**OHIO RIVER BRIDGES  
SECTION 4 - EAST END BRIDGE APPROACH  
VALUE ENGINEERING STUDY REPORT**

**Study Date: December 10 - 14, 2007  
Report Date: January 4, 2008**

**VALUE ENGINEERING STUDY  
for  
Kentucky Transportation Cabinet**

# VALUE ENGINEERING RECOMMENDATION # VE-12

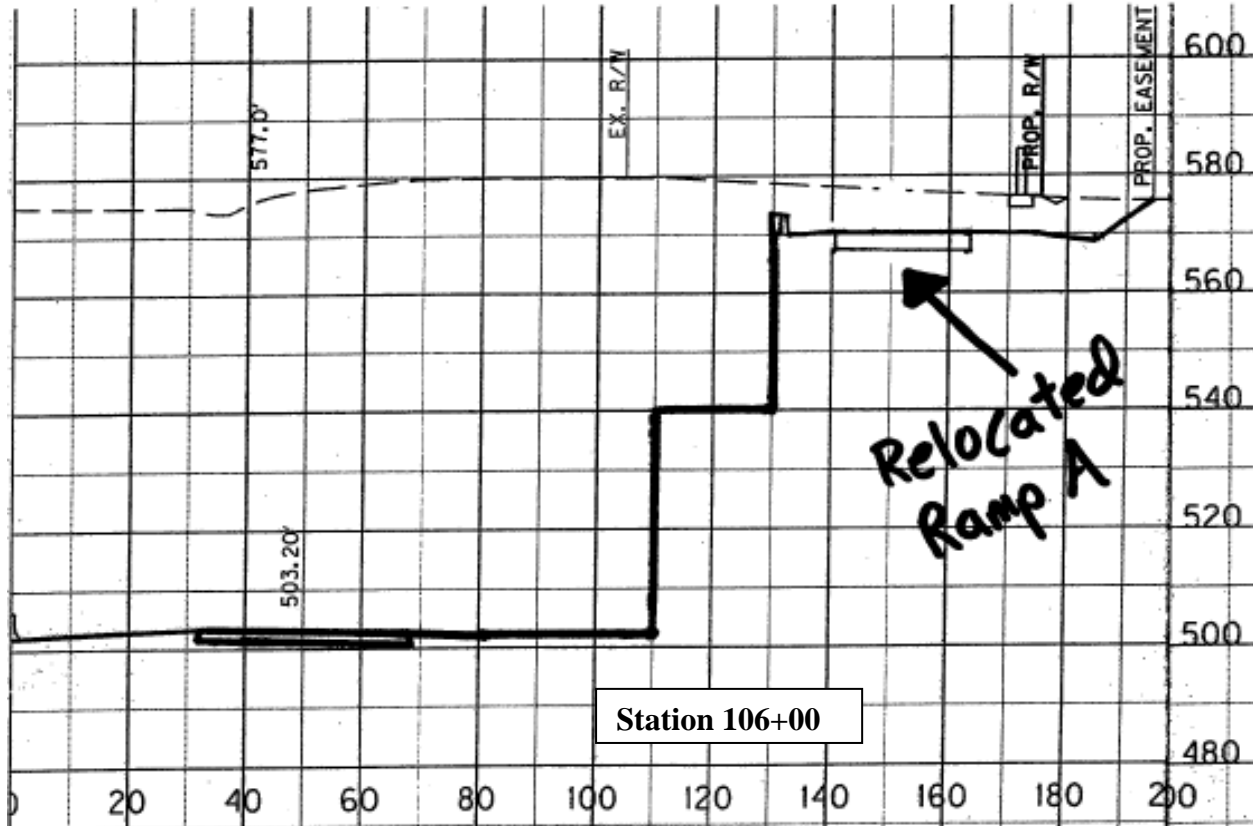
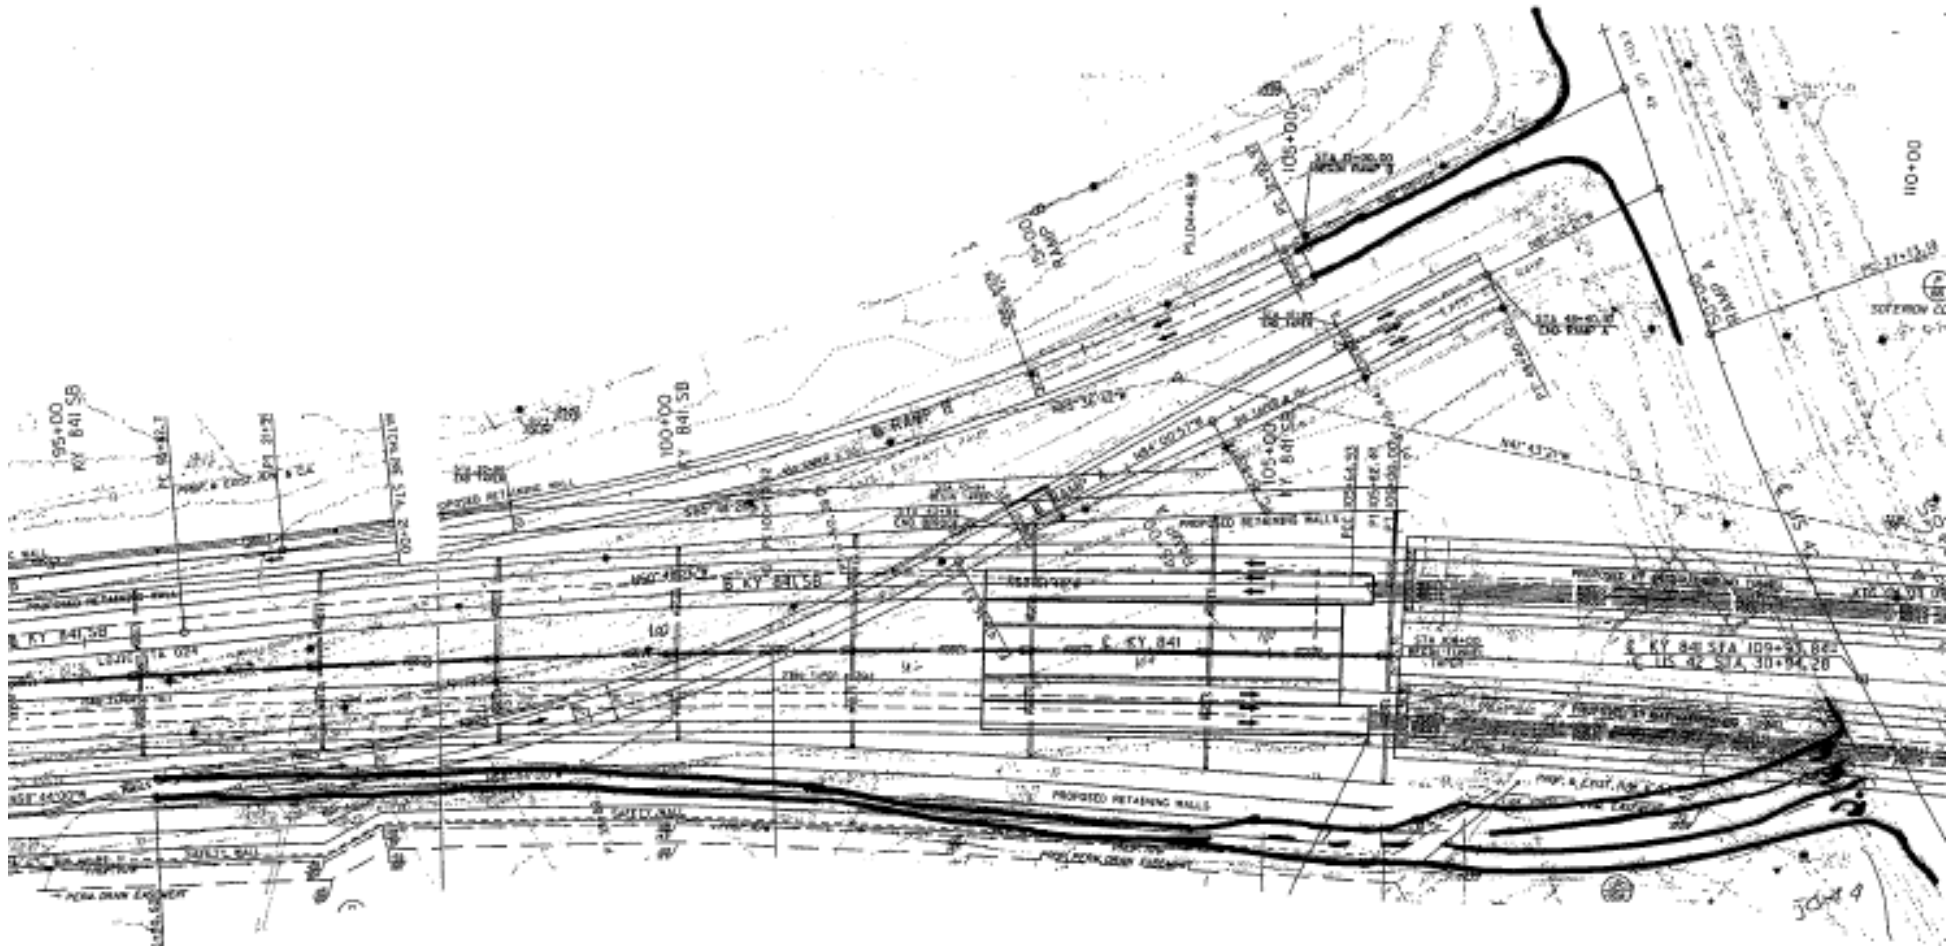
- Eliminates bridge
- Conforms with driver expectancy-exit ramps go off to the right and end at a one-way surface street intersection

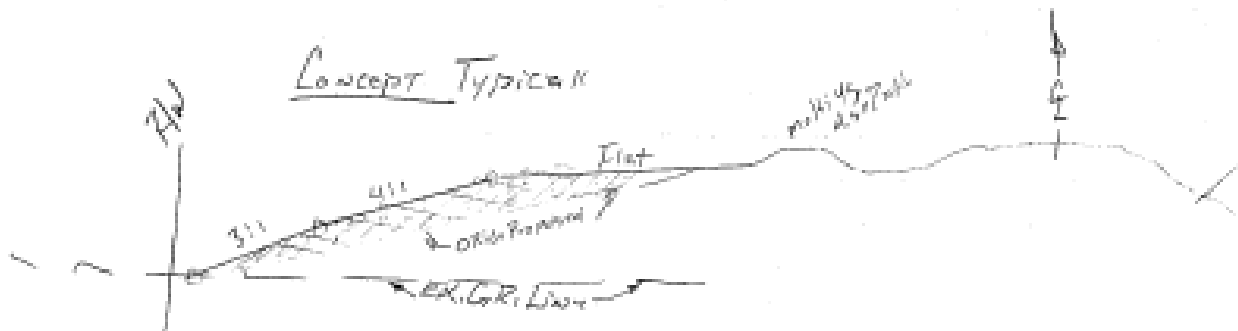
Lt. 156+00 To 168+00 = 1200'

Rt. 158+00 To 168+00 = 1000'

Average End Area Lt 4:1 700<sup>sq</sup>  
 3:1 To 4:1 To Flatter. Rt 4:1 500<sup>sq</sup>

$$\begin{aligned} \text{Lt Volume} &= \overset{\text{Length}}{1200} \times \overset{\text{Average Area}}{700} = 840,000 \text{ Ft}^3 \\ \text{Rt " " " } &= 1000 \times 500 = \underline{\underline{500,000}} \end{aligned}$$
